4.1 Site Plan - Mountain America Credit Union

Date: June 21, 2023
From: Cache Hancey, Planner & Business Advocate
To: Planning Commission
Item: Mountain America Credit Union Site Plan (PLAN 23-010)
Applicant: Brooke Bean, Sanders Associates Architects

**RE: MOUNTAIN AMERICA CREDIT UNION THE YARD BRANCH
SITE PLAN REVIEW 1ST REVIEW COMMENTS – SAA RESPONSE**

SHEET NO.
L1.1

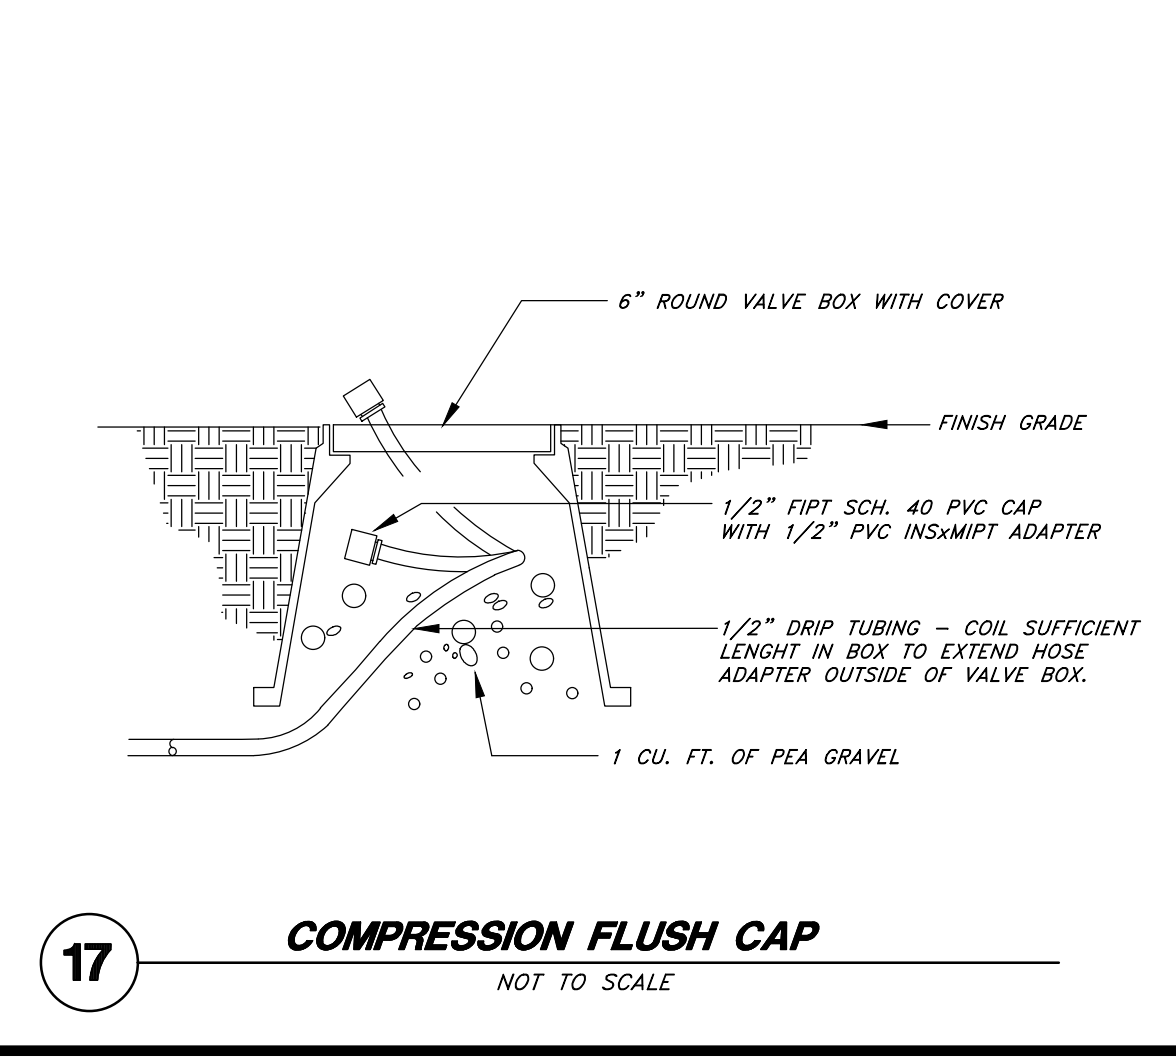
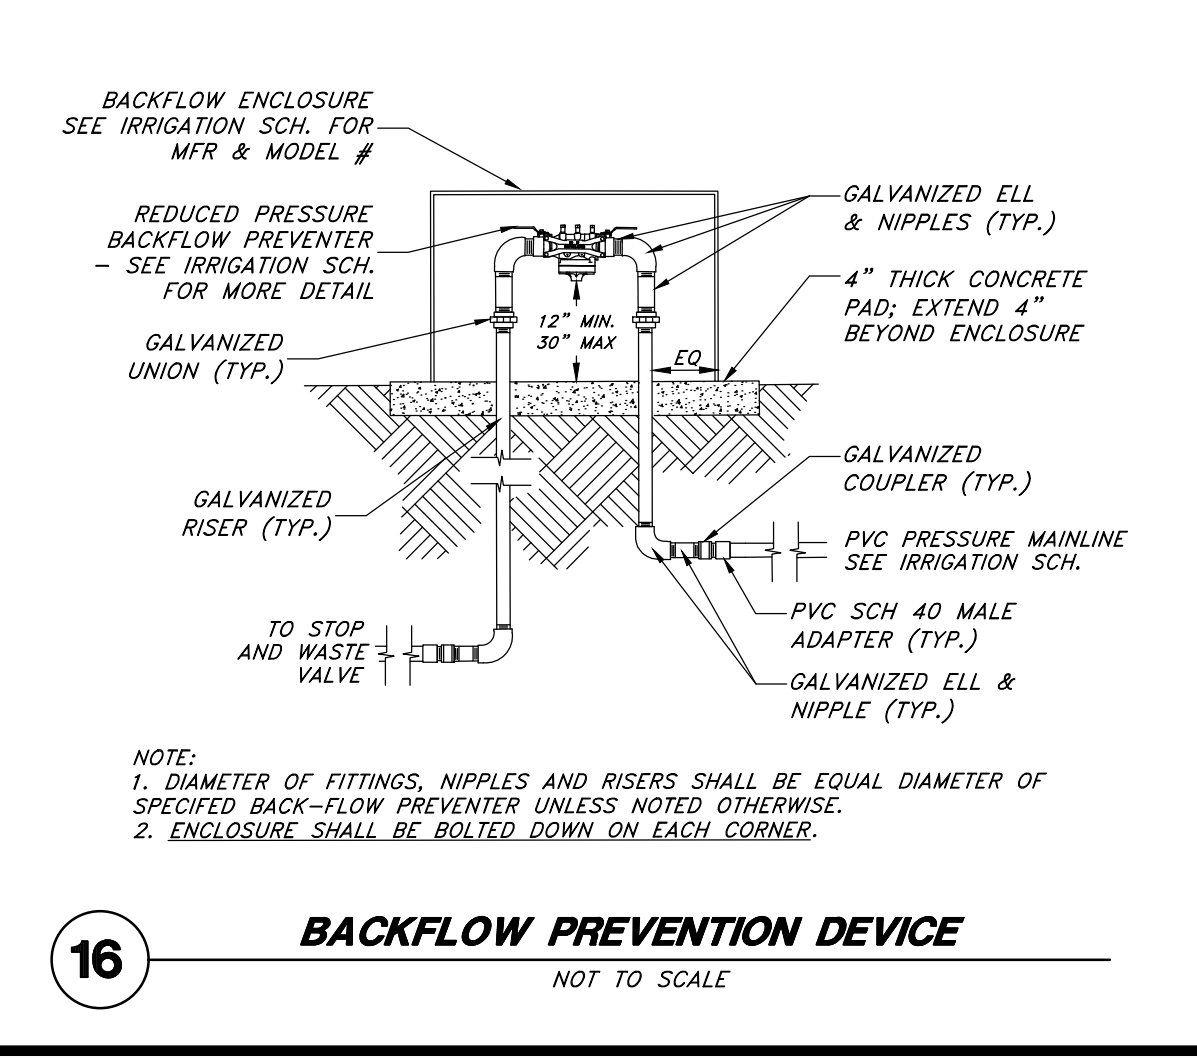
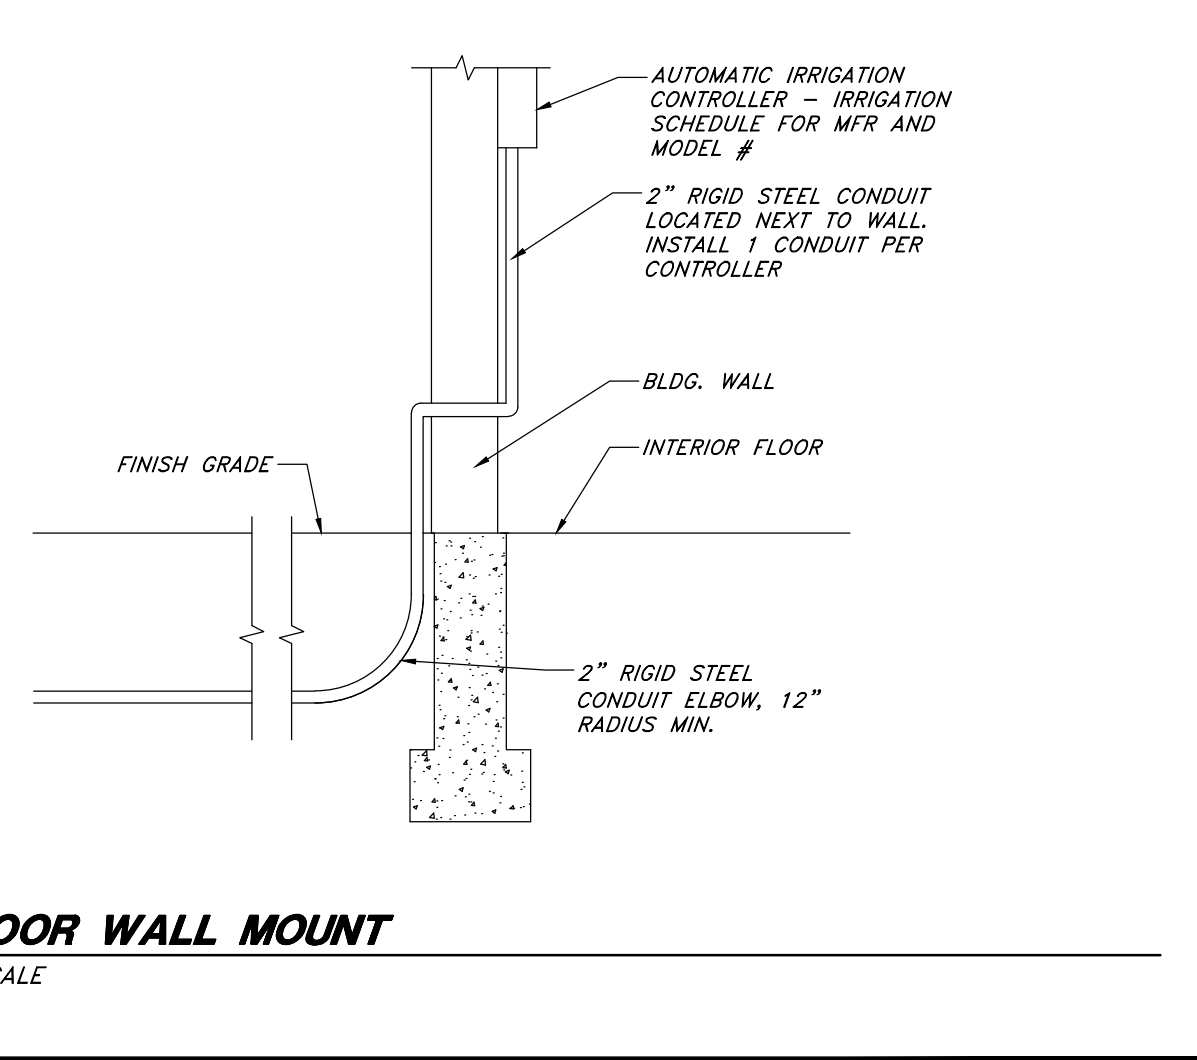
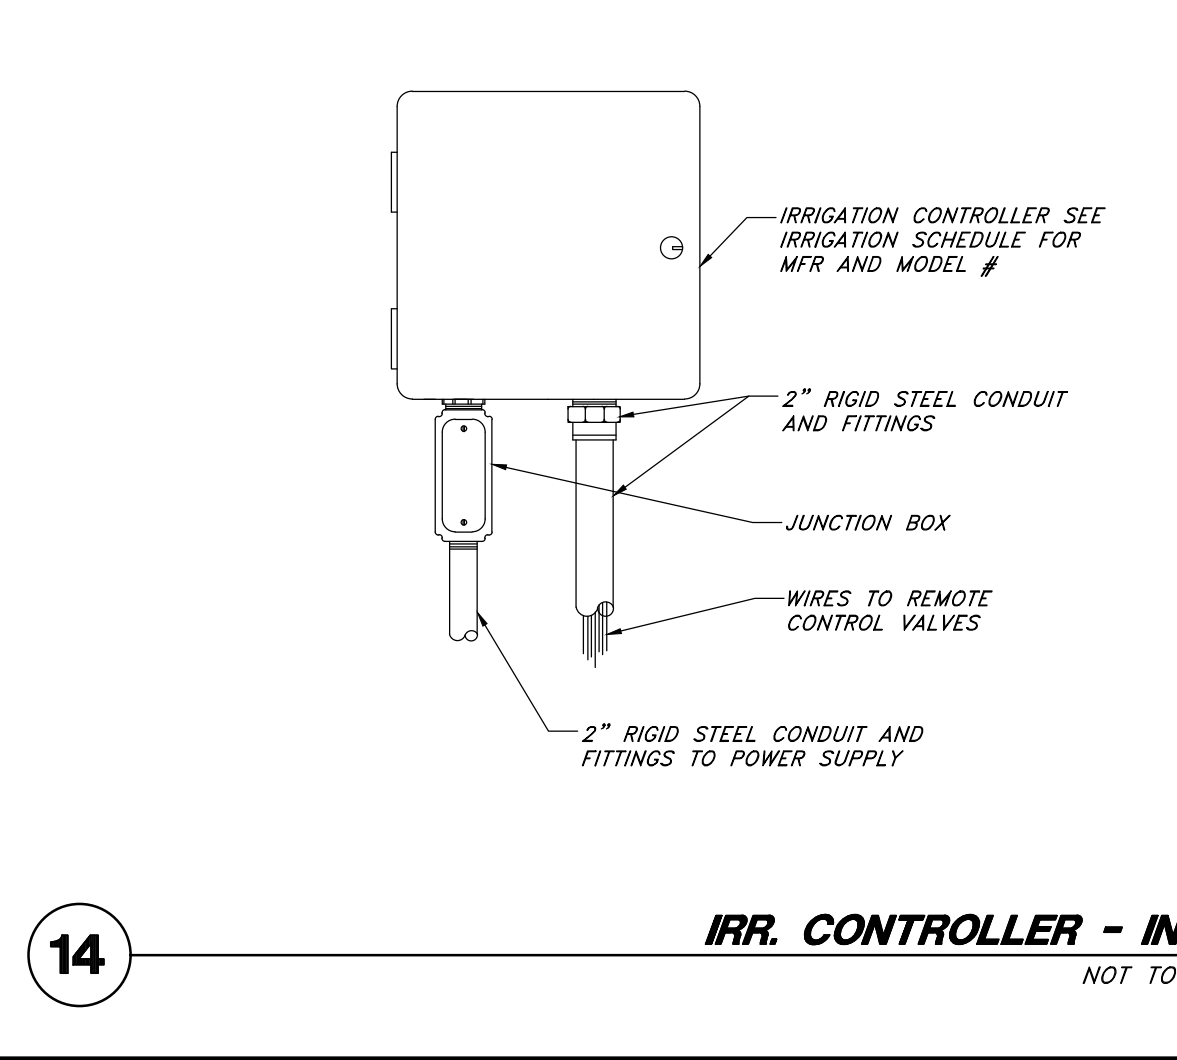
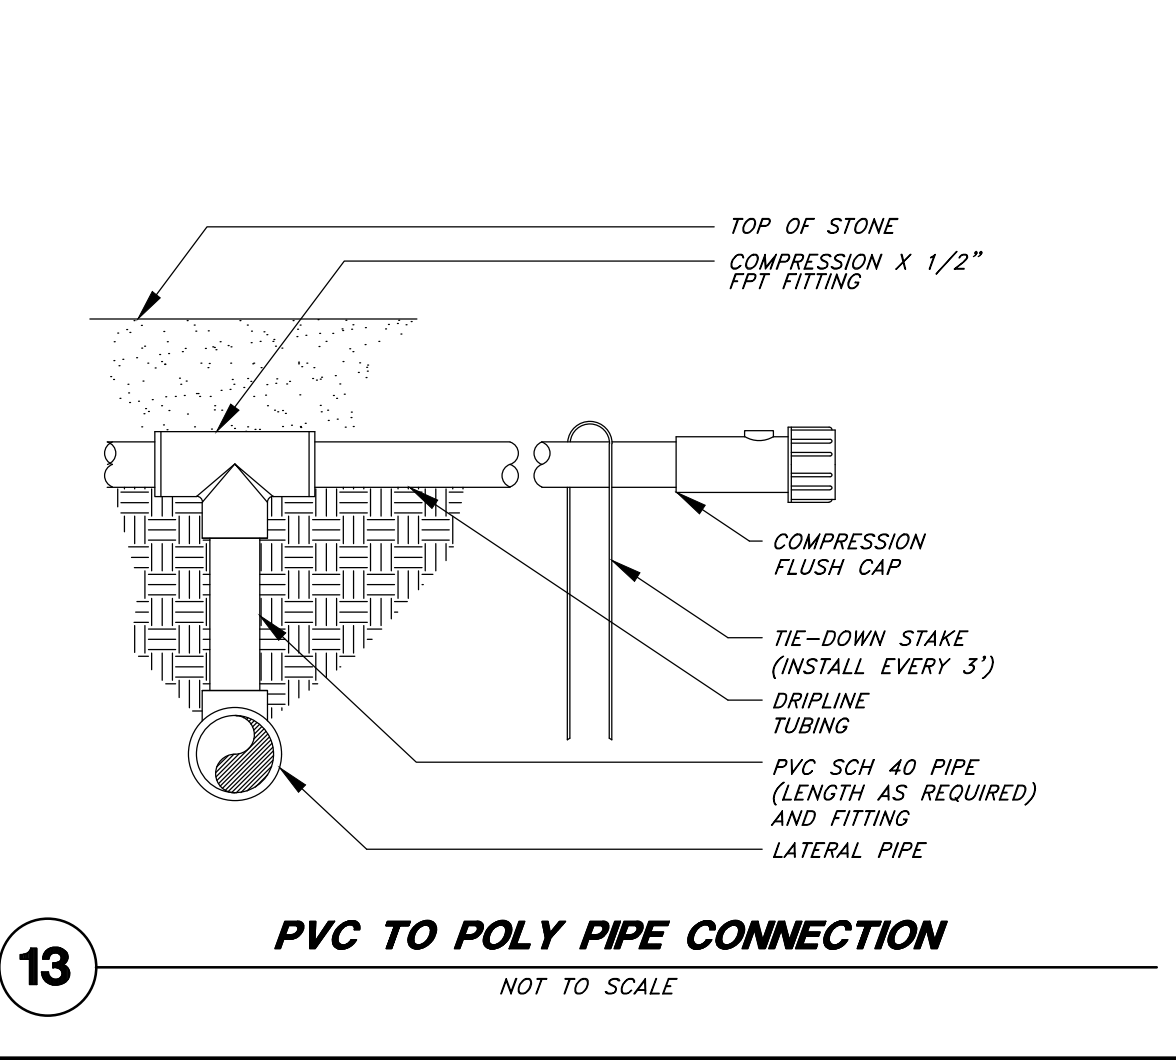
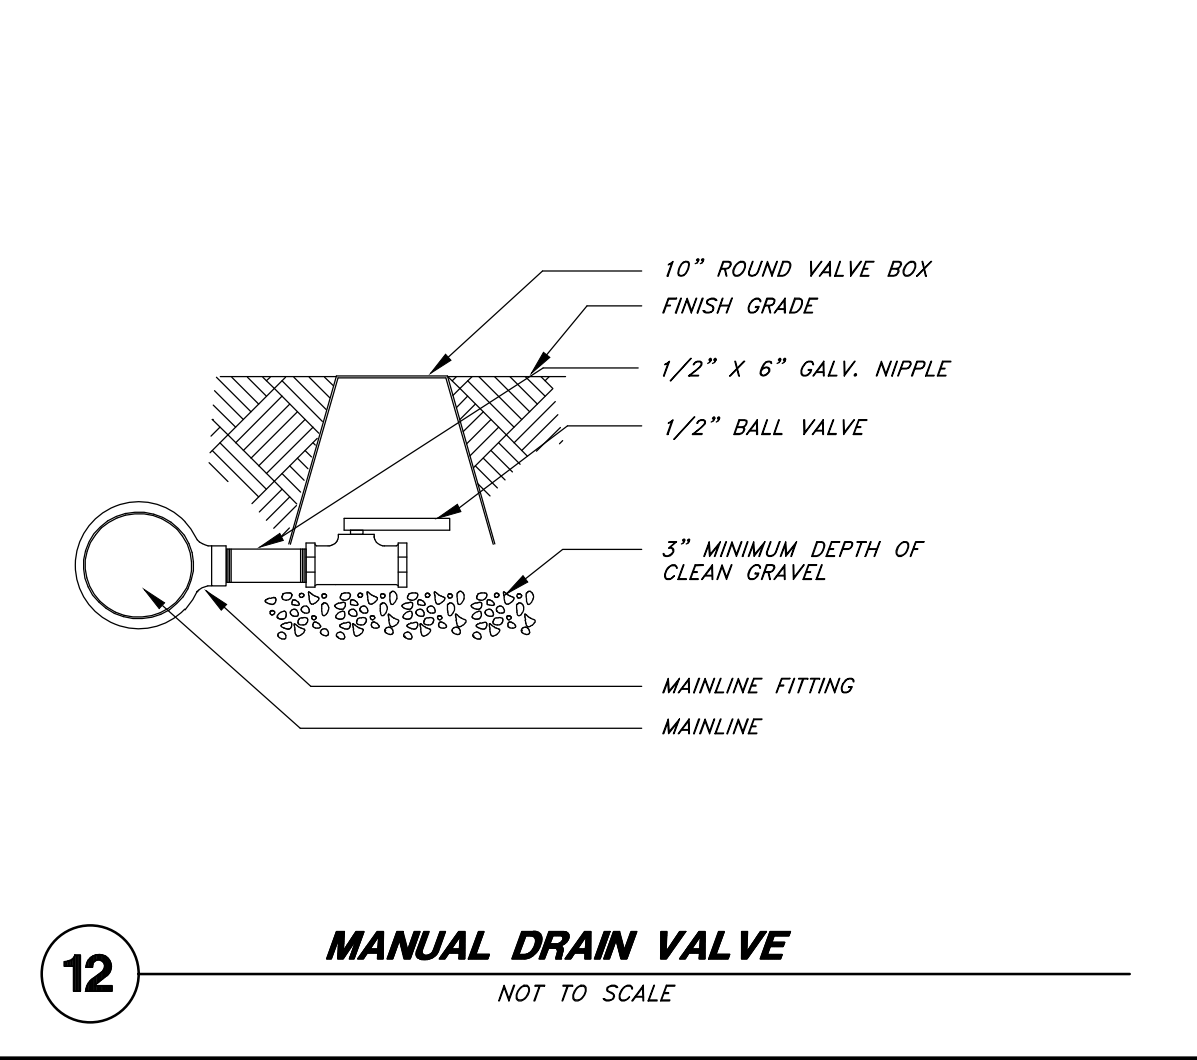
2. *Detention basins cannot be used towards the open space calculation.*
AWA Response: Detention area has been removed from the Landscaping calculations.

AWA Response: See sheet L1.1 for plant schedule with approved plants and their mature size. Also sheet L1.1 and L2.1 for seasonal landscape and irrigation maintenance requirements.

AWA Response: The detention pond shall have a maximum slope of 4:1 in slope. See sheet L1.1 with slope areas indicating slopes in pond.

PHOTOMETRIC SITE PLAN

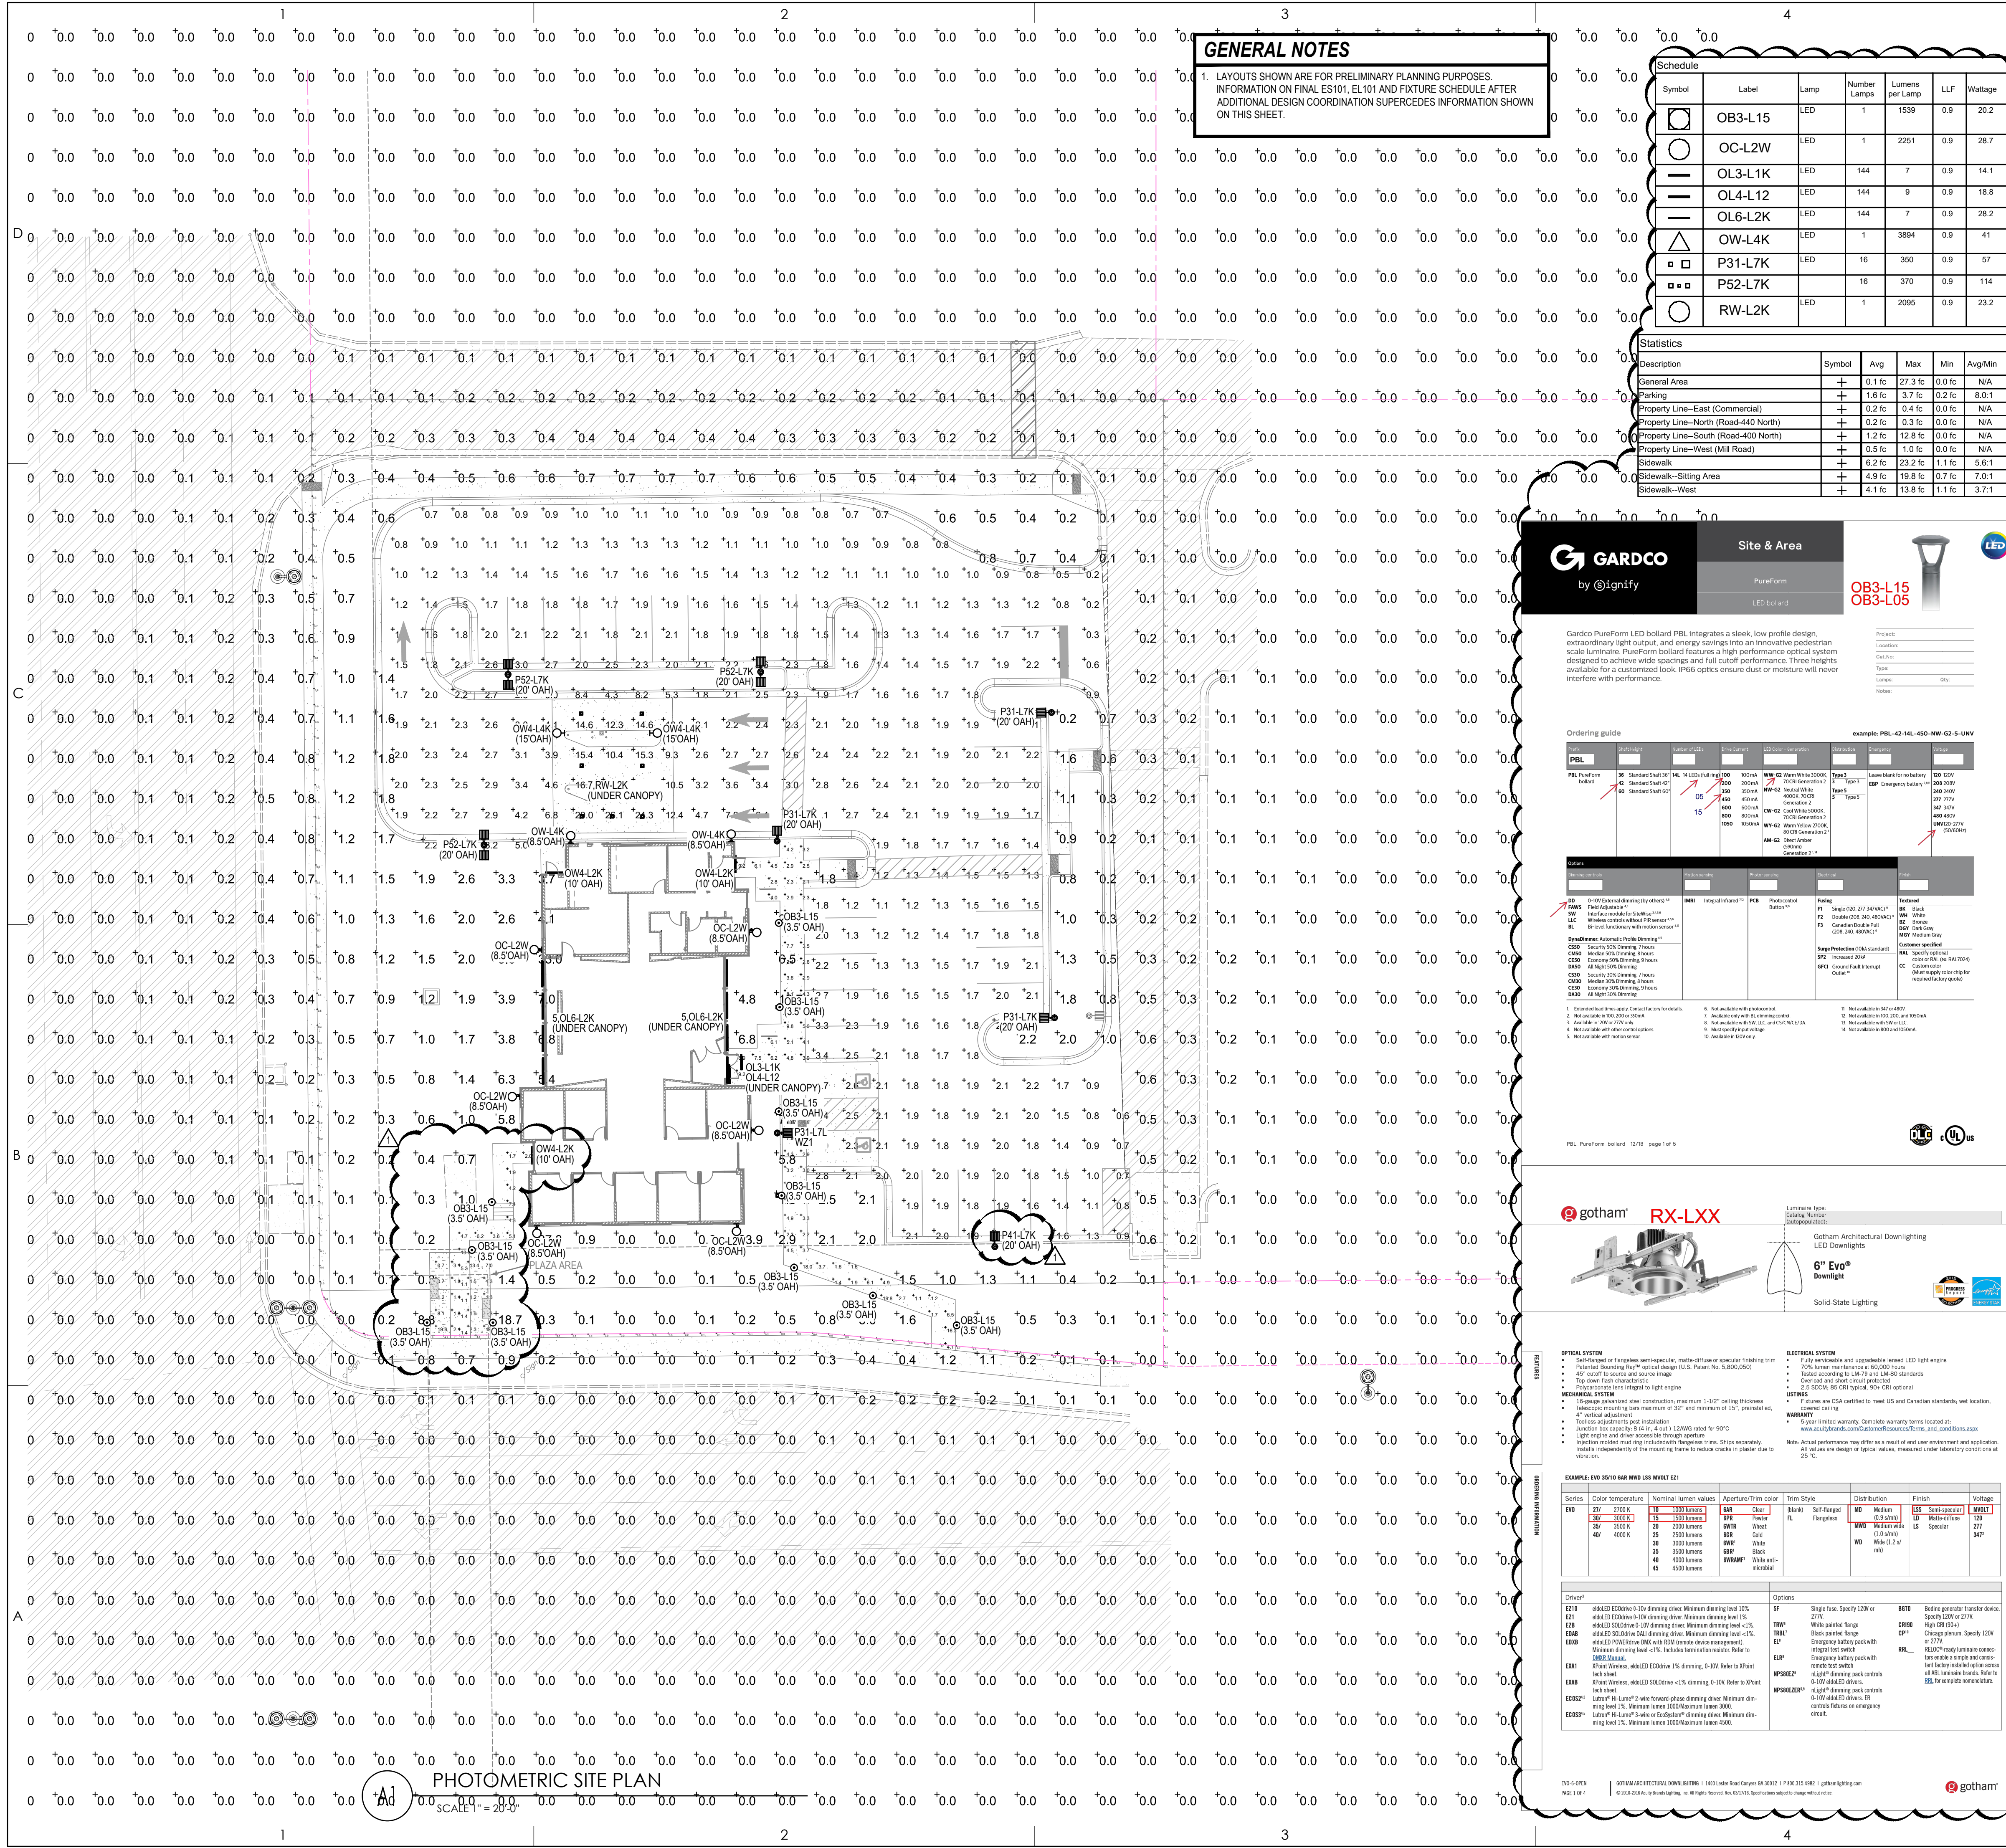
5. *Regarding site lighting: Light poles cannot exceed 20 FT in height; All lighting must be shielded and down-lit.*
SSE Response: Light poles are 20 FT in height. All site lighting will be shielded and down-lit. Refer to ES102.
